ISO/IEC JTC1/SC2/WG2/IRGN2430EisoReview

Review on Submission of Macao's Vertical Extension (UNC

Title: Characters), Horizontal Extension, and IVSes Registration

Source: Eiso Chan (陈永聪, Culture and Art Publishing House)

Fig. 4.1.2 MD-6681

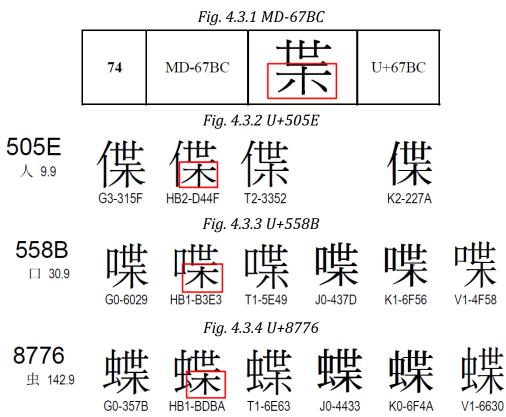
MD-5C2D is the component of MD-6681, but they have minor differences.

It is better to make the glyph of same component consistent.

4.5. MD-6DF8 glyph

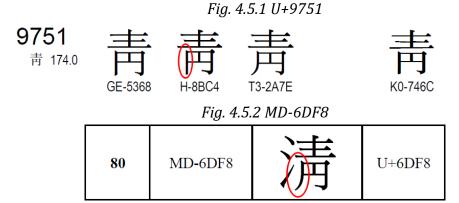
In Hong Kong SAR conventions, the first stroke of the bottom of U+9751 (青) is the vertical bar (竪/豎) not the slash (撇).

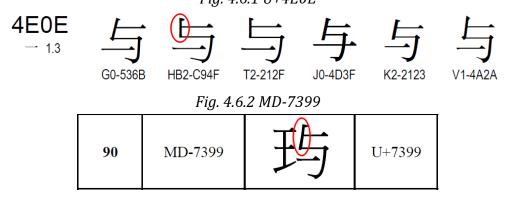
In Hong Kong SAR conventions, the first vertical stroke of U+4E0E (与) should be straighter. Fig. 4.6.1 U+4E0E

4.7. MD-74C7 glyph

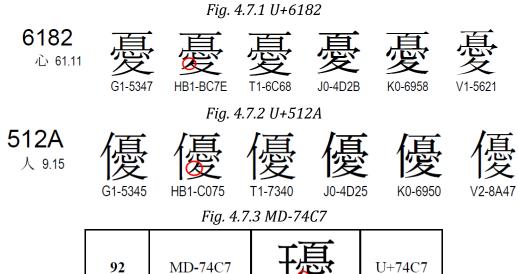
In Hong Kong SAR or Macao SAR conventions, the bottom component of U+6182 (憂) should be U+5902 (夕) not U+590A (久).

4.8. MD-784F glyph

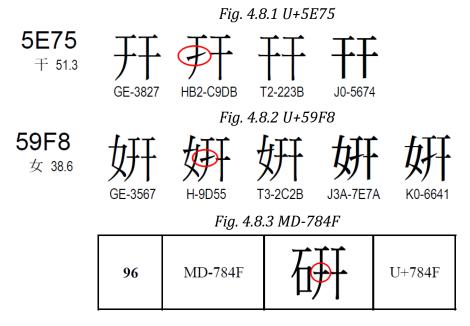
In Hong Kong SAR conventions, the second stroke of the middle component should be tí (提/剔).

4.11. MD-7BB6 glyph

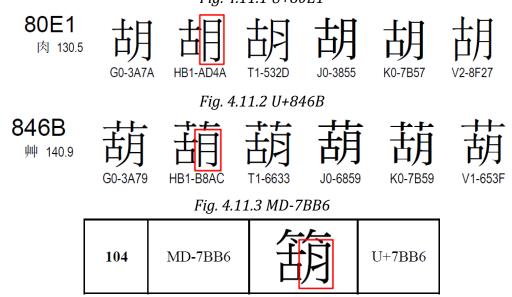
In Hong Kong SAR conventions, the right part of U+80E1 (胡) should be U+2E9D (目). Fig.~4.11.1~U+80E1

4.13. MD-4058 MD-7E4E glyph

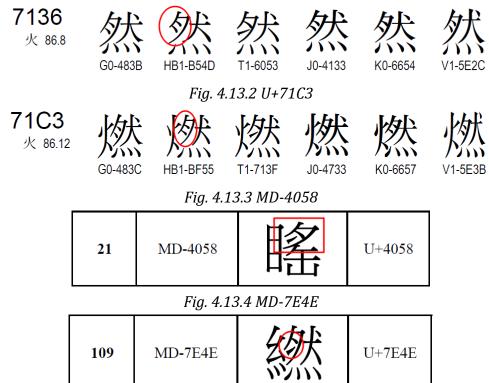
In Hong Kong SAR conventions, the internal two dots of the upper-left component of U+7136 (然) should be parallel.

4.15. MD-9759 glyph

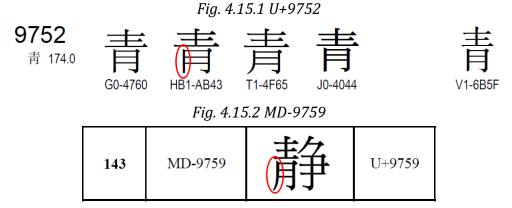
In Hong Kong SAR conventions, the first stroke of the bottom of U+9752 (青) is the vertical bar (竪/豎) not the slash (撇).

4.16. MD-9B30 glyph

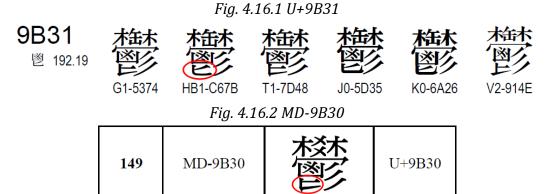
In Hong Kong SAR conventions, the bottom left component is different. Notice that U+9B30 (鬱) is the variant of U+9B31 (鬱).

4.18. MC-00012, MC-00015, MC00052, MC-00094, MC-00123, MD-370F MD-216E9 MD-218DD MD-2BC3E, MDH-5AAA glyph

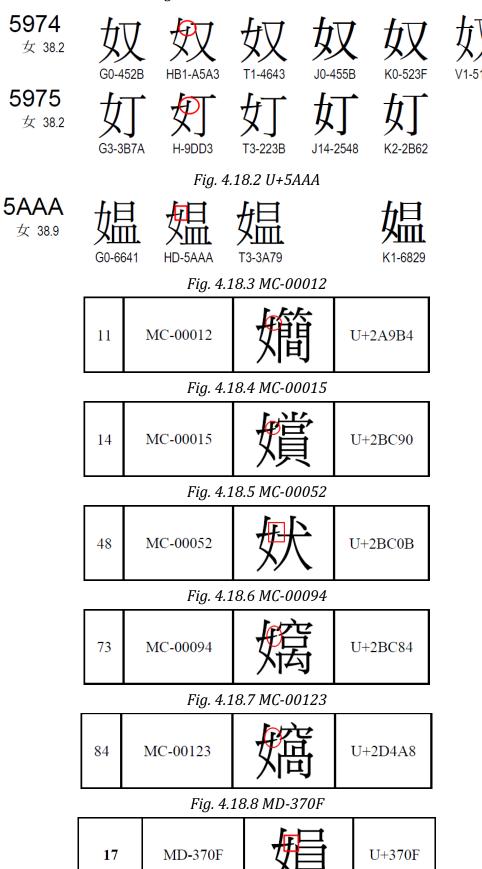
In Hong Kong SAR conventions, the last stroke of the component $U+5973~(\cancel{\pm})$ should be shorter when it is set as the left component.
